Subject: New Trash service at 20795 Linear
Date: Monday, July 31, 2023 at 8:13:12 AM Pacific Daylight Time
From: Cheryl Miller
To: Brian Prock
CC: Ronette Martinez
Attachments: image001.jpg, 2023-06-27 trash CRR.pdf

Subject: RE: Revised Trash service at 20795 Linear, request for specs.
Date: Monday, July 31, 2023 at 11:21:43 AM Pacific Daylight Time
From: Cheryl Miller
To: Brian Prock
CC: Ronette Martinez, Keaton Ereth, Tim Bundy, Joel Anderson, Charles Trowbridge, Scott Griffiths, Jason Wade, Angelo De Guzman
Attachments: image002.jpg, image003.jpg

Subject: Revised Trash service at 20795 Linear, request for specs.

SK-1
04-20-23

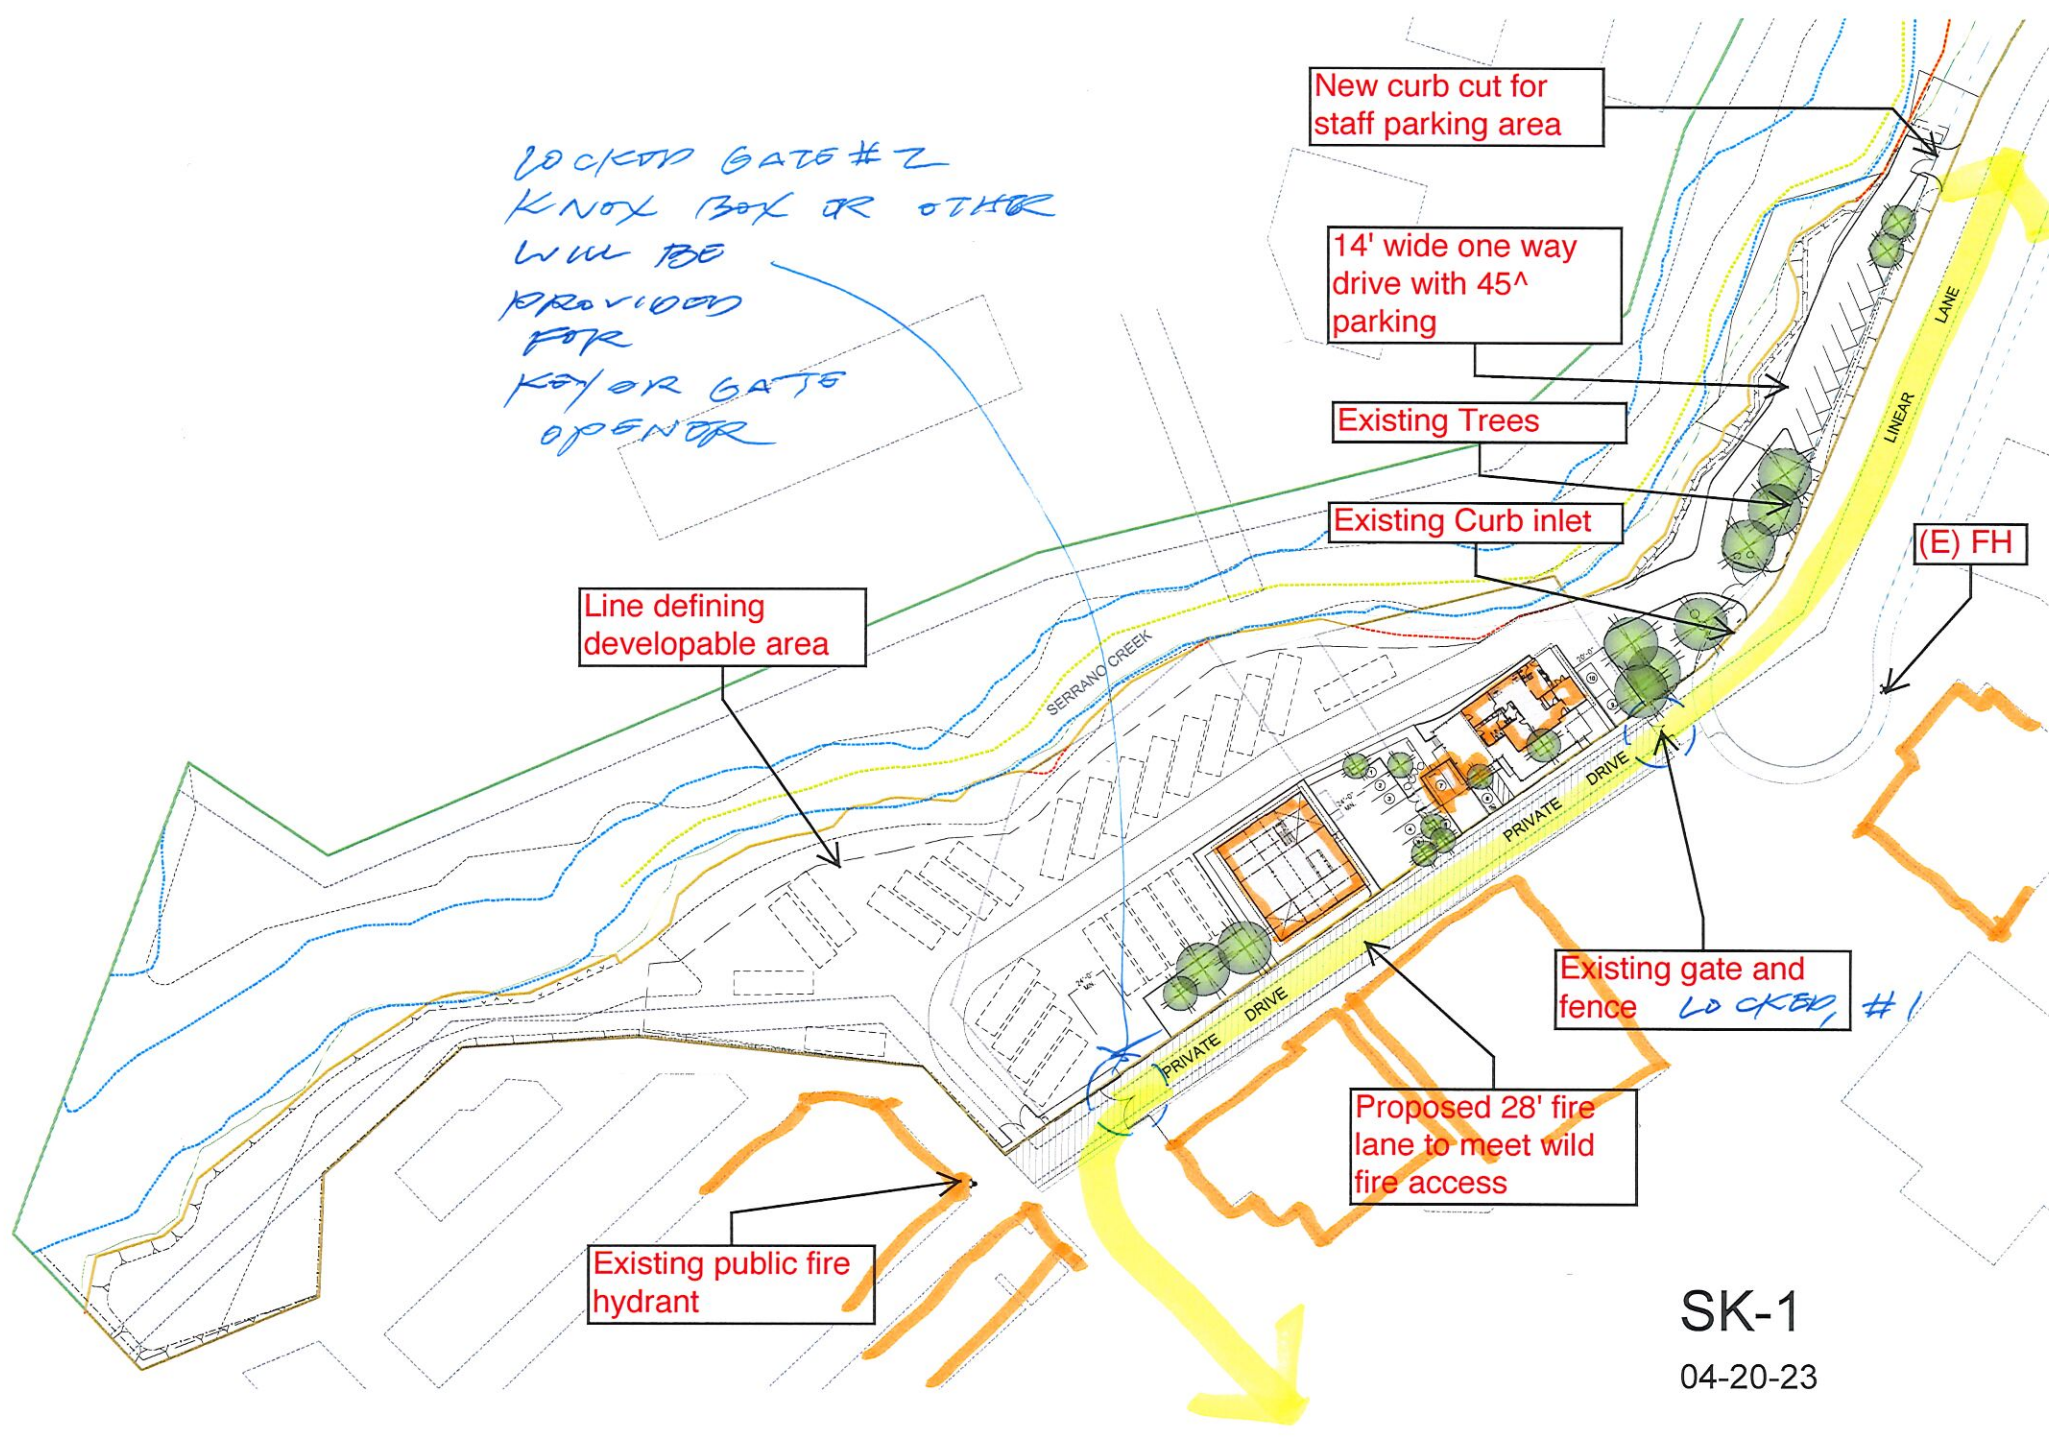
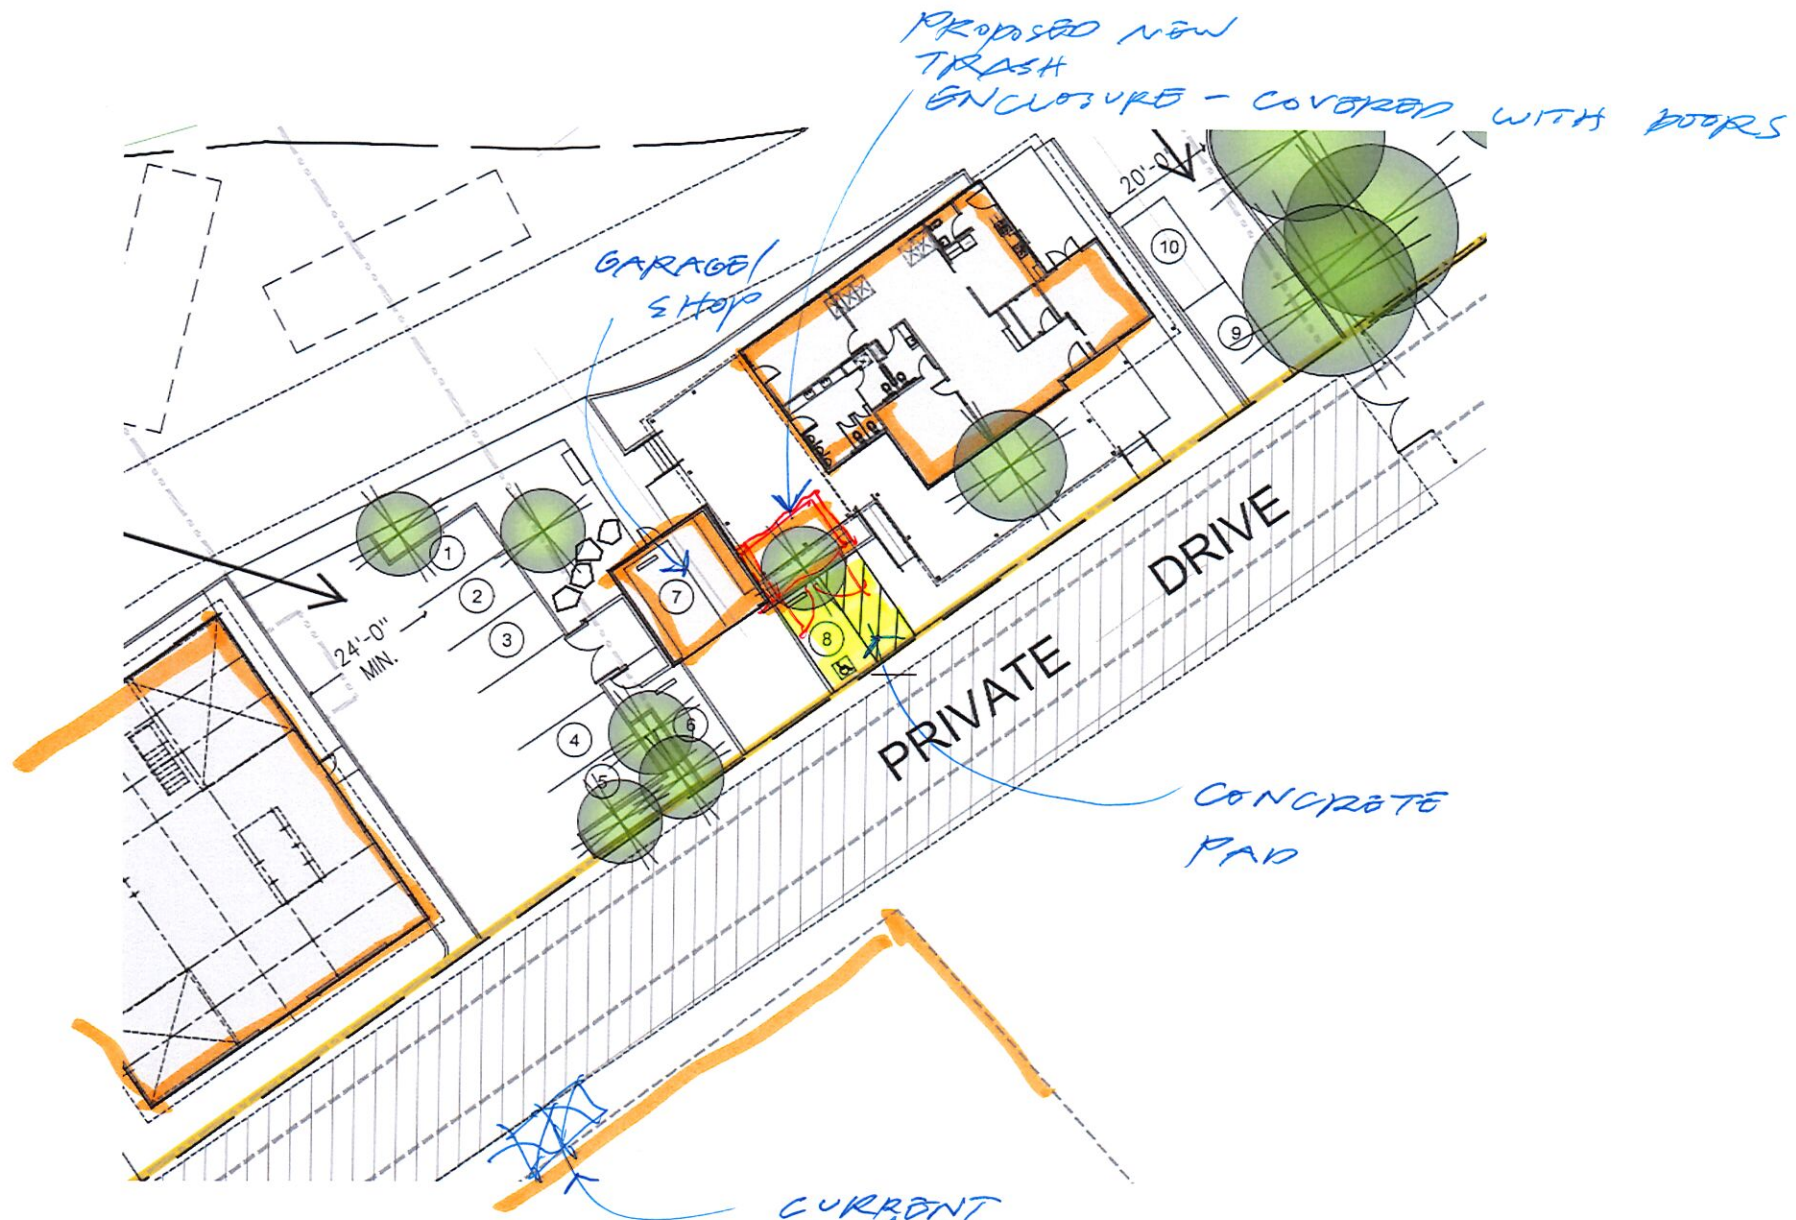
CR&R has reviewed the attached site plan for the planning area 20795 Linear, Lake Forest. Based on the plan diagrams received via email, CR&R has determined we are able to accommodate the proposed trash can placement.
